Lief and Sani Morin
35 Hilltop Dr
Seaside, OR 97138

City of Seaside Planning Commission
c/o Mr. Kevin Cupples
Seaside Planning Director
989 Broadway
Seaside, OR 97138

RE: Planning Commission Hearing December 7, 2021
Proposed Development #21-061 PDSUB

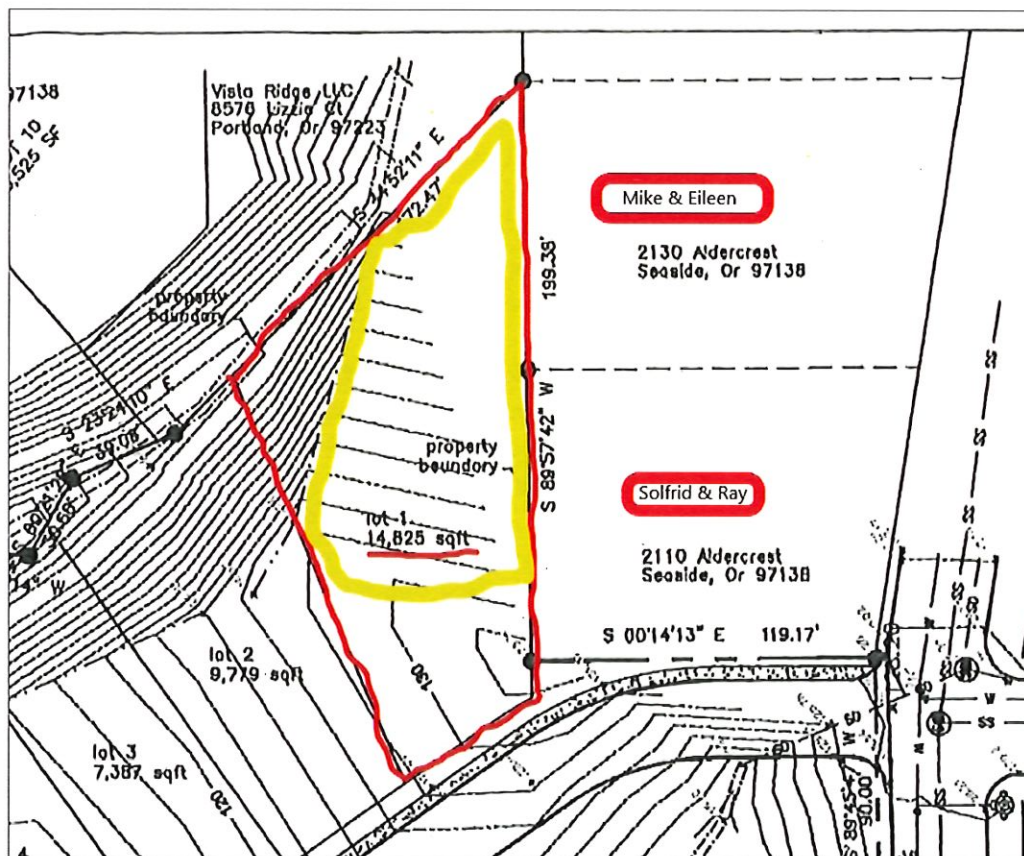
6. The buildable area shown in the newly submitted information titled “Lot Building Areas,” and the application states that a building could be placed within five feet of the top of slope. Five feet of erosion will occur over the expected lifetime of the speculative houses. That amount of erosion could happen in the first few years.

The standard set for the Vista Ridge 1 development as described in the 2004 geotechnical report was a 20’ setback for any foundations from the crest of slopes. It is unclear as to why this application would need less of a setback. The building area may be further challenged by some of the lot shapes and steep terrain and the poor quality of the map submitted.

Appendix D1 – Contour Maps and Site Plans

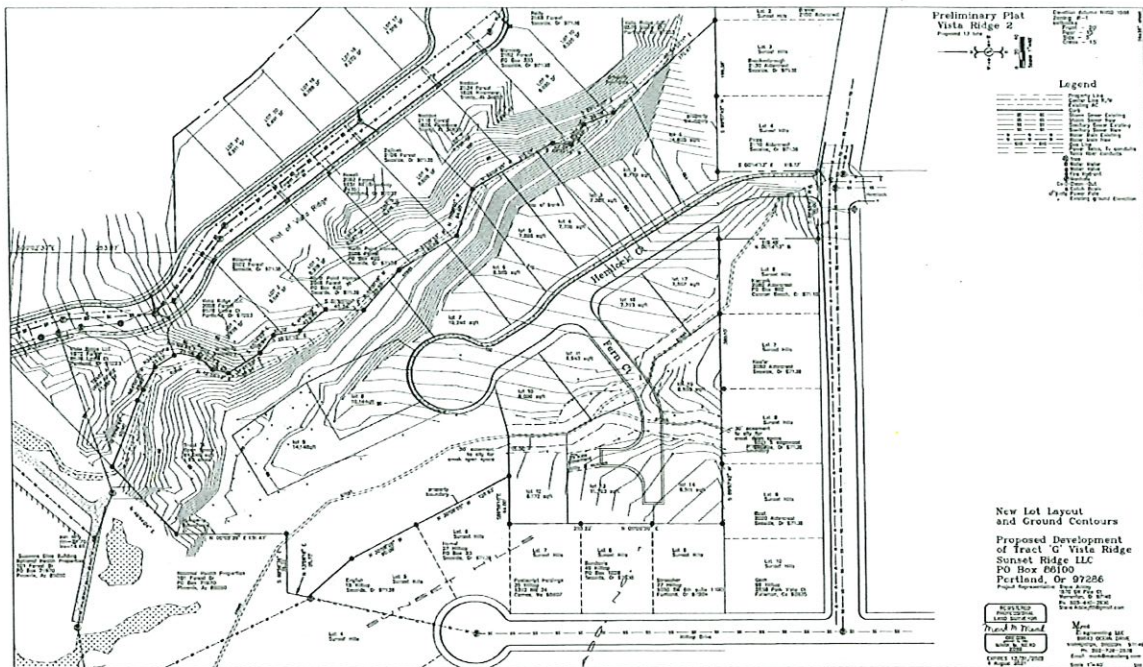
The application also does not include contours on the adjacent properties. QQQQ SZO Those contours are important to for Planning Commission and public evaluation of an application to understand if and how neighboring properties might be affected. Here is one snippet from the contour map that was included in the original application with markup and a brief comment:

Lot #1 in Red, the slope lines in yellow do not portray the actual slope
Source: Applicant's report with markups (No high-res version available)

Appendix D4 – Contour Maps and Site Plans

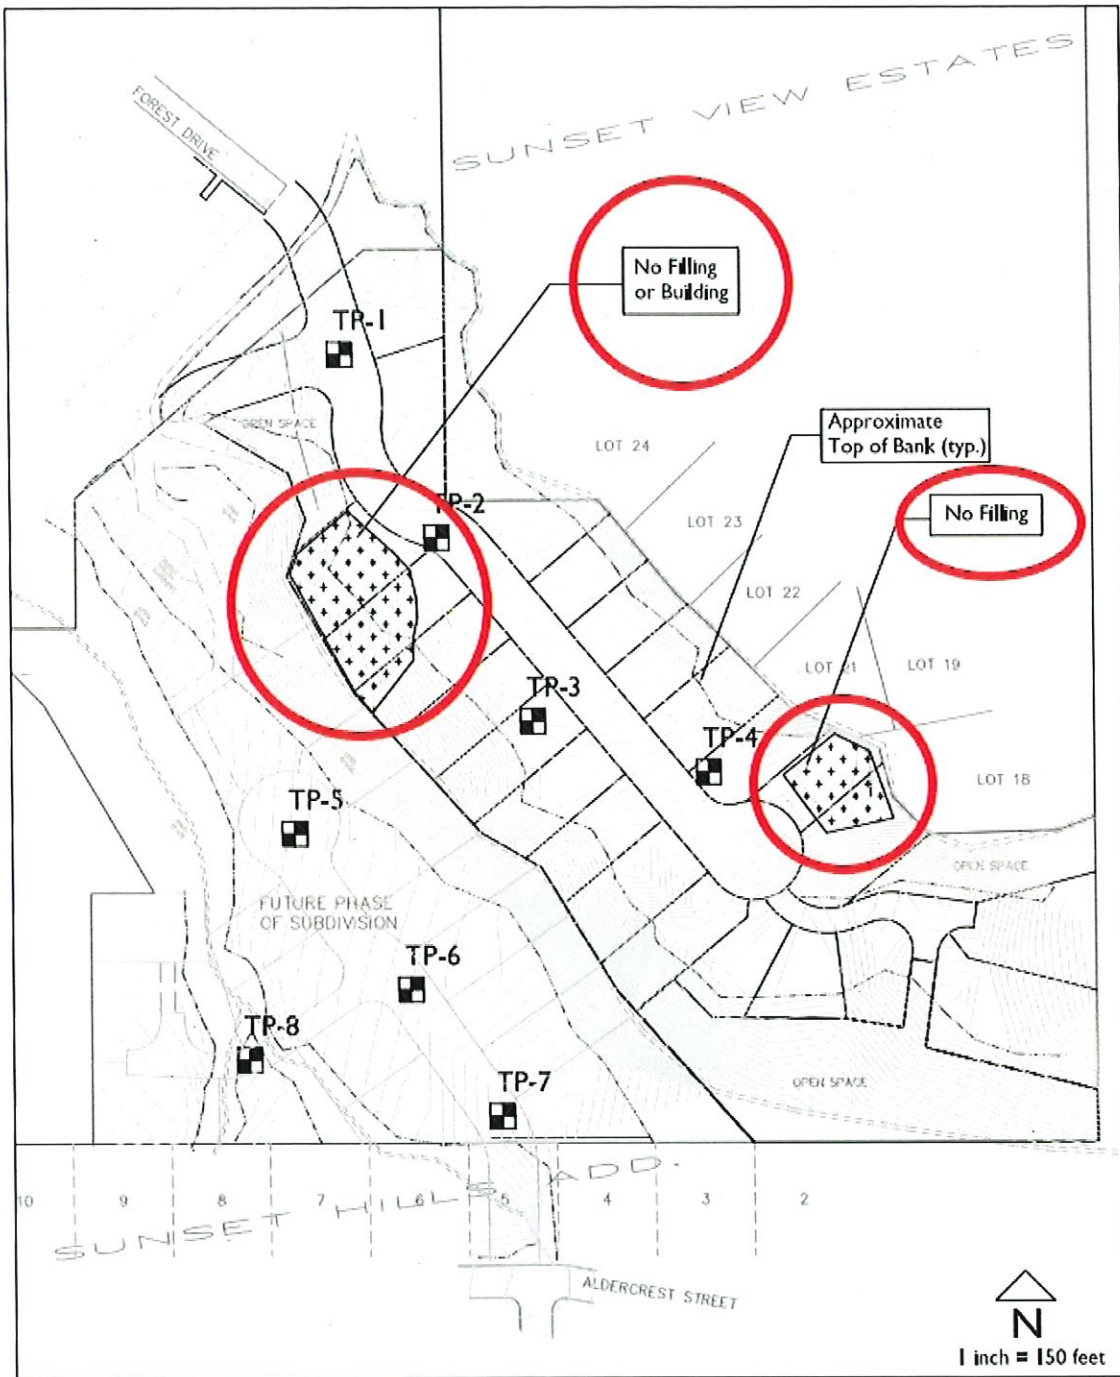
1. The top of bank for the east stream is not where it is indicated in the application. The corrected top of bank line is shown on the map above in green. This correction impacts at least seven of the buildable areas on the lots as currently drawn.
2. The house footprints, along with the property setbacks shown, in the Sunset Hills neighborhood are significantly larger than any of the speculative houses (not shown).
3. Specifically, the odd shapes of both lots #14 and #15 cannot support houses that would be in keeping with the character of either of the adjacent developments.
4. The west stream (in show red) does not follow the contour lines and shows the water in that stream flowing uphill.

5. The path and sewer line are shown traversing private property. No discussions with, or permissions given from the landowner have been mentioned on public record. There is reasonable cause to doubt that Suzanne Elise would want a path that directly connects to the back of the property where elderly residents live on the first floor. They would also likely object to the significant construction activity adjacent to and on their property.

10. Two lots (and part of a 3rd lot) in Vista Ridge 1 that are shown on the site plan were designated as a No-Build / No-Fill zone in the 2004 geotechnical report for that project. Since then, a house has been built on one of the lots and the other is actively being marketed as buildable land.
